URGENT FIELD ACTION NOTICE

Affected Products: ULTIMA washer/dryer series (1400LX, 1400LXP and 1600LXP)

Product Issue: Getinge Life Science has received complaints where the screed/cylinder link of the ULTIMA washer/dryer was broken, leaving the door no longer retained when opened which may result in an unreasonable risk of harm to the user.

Figure 1: hydraulic/pneumatic braking mechanism

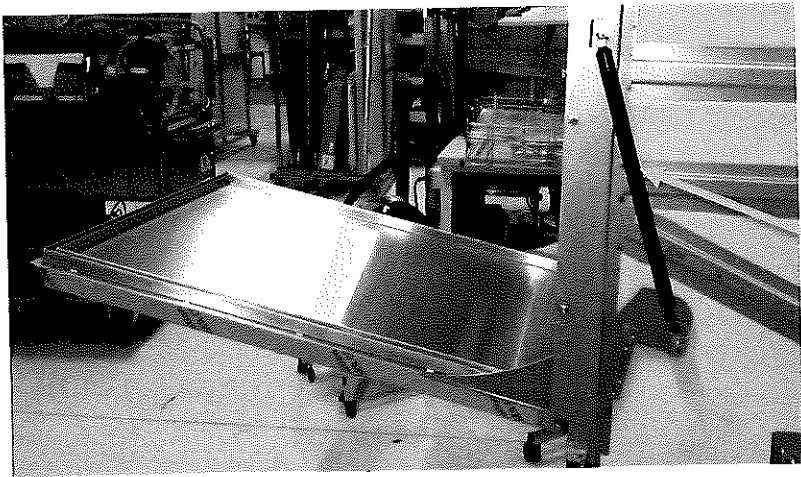
Getinge Life Science is initiating an Urgent Field Action Notice for the ULTIMA washer/dryer series (1400LX & 1400LXP and 1600LXP) due to the potential malfunction of the hydraulic/pneumatic braking mechanism, shown in Figure 1, which may result in an unreasonable risk of harm to the user.

This Urgent Field Action Notification is to inform customers with the affected product to remove from area(s). Subsequently, an upgrade kit will be provided to replace existing door fixating mechanism with a new one. The installation will be done by Getinge service technicians at no charge to the customer. You will be contacted by a Getinge Service Technician when the upgrade kit is ready for installation at your facility.

Figure 3: Screed/Cylinder link breaking

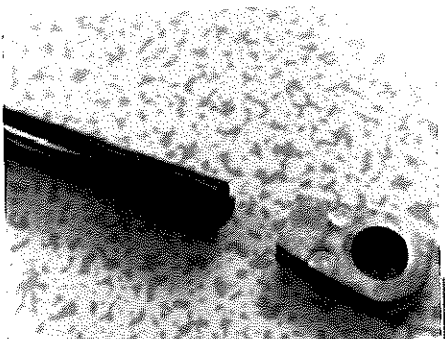
This potential for malfunction is caused by a failure of the screed/cylinder, shown in Figure 2, due to the part being too constrained resulting in a rupture of the screed/cylinder link, as shown in Figure 3.
